Access Compliance Report Public Rights-of-Way (Curb Ramps)

Intersection ID: 48865	Main Street: TIGRESS_CT	Cross Street: ERWIN_RD	Location: NE
ADA ID: 2C861CD51B5F	Ramp Type: PerpDiag	Initial Pass/Fail: Fail	Overall Compliance: No Severity Score: 12.5

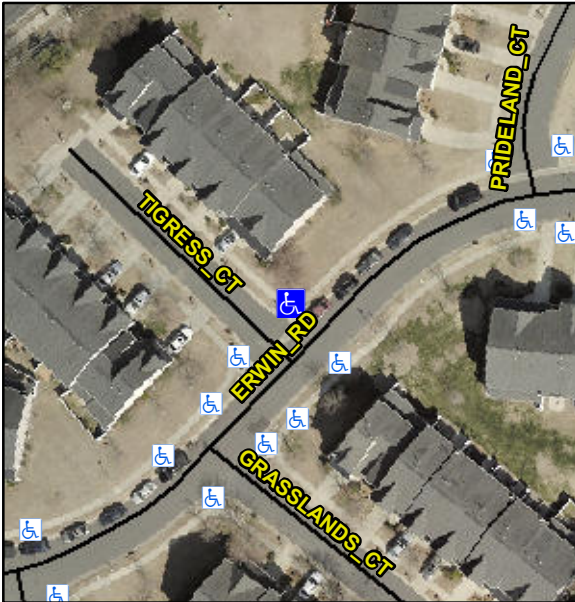
PROW/ADA:
Not Found, R304.5.3

Compliance	Description	Data	Compliance	Description	Data
N/A	Ramp Length (in)	48.0	Yes	Ramp Slope (%)	7.0
Yes	Ramp Width (in)	48.0	No	Ramp XSlope (%)	5.6
N/A	Flare Type LT	N/A	N/A	Flare Type RT	N/A
N/A	Flare Slope LT (%)	N/A	N/A	Flare Slope RT (%)	N/A
N/A	Flare Traversable LT?	N/A	N/A	Flare Traversable RT?	N/A
N/A	Landing Length (in)	N/A	N/A	DWS Provided?	N/A
N/A	Landing Width (in)	N/A	N/A	DWS Contrast?	N/A
N/A	Landing Slope (%)	N/A	N/A	DWS Length (in)	N/A
N/A	Landing X Slope (%)	N/A	N/A	DWS Full Width?	N/A
N/A	Landing Curb? (Y/N)	N/A	N/A	DWS Offset (in)	N/A
N/A	Shared Landing?	N/A			
N/A	Gutter Ponding?	N/A	N/A	Gutter Slope (%)	N/A
N/A	Gutter Lip Ht (in)	N/A	N/A	Gutter X Slope (%)	N/A
N/A	Painted X Walk1?	No	N/A	Painted X Walk2?	No
	X Walk 1 Direction	To SW		X Walk 2 Direction	To SE
N/A	X Walk 1 Width (in)	N/A	N/A	X Walk 2 Width (in)	N/A
	X Walk 1 Slope (%)	0.5		X Walk 2 Slope (%)	2.1
	X Walk 1 X Slope (%)	3.3		X Walk 2 X Slope (%)	2.1

N/A	Ramp inside XWalk1?	N/A	N/A	Ramp inside XWalk2?	N/A
	Road Slope (%)	4.1	N/A	Clear Space?	N/A
	Road X Slope (%)	0.2	N/A	Clear Space to XWalk (in)	N/A
N/A	Any Obstructions?	N/A	N/A	Storm Grate/Utility Hazard?	N/A
	Obstruction Type			Storm Grate/Utility Type	
		N/A			N/A
			Yes	Surface Condition? (G/P)	Good

Possible Solutions:
Remove & Replace Curb Ramp With Two New Directional Ramps or Equivalent.
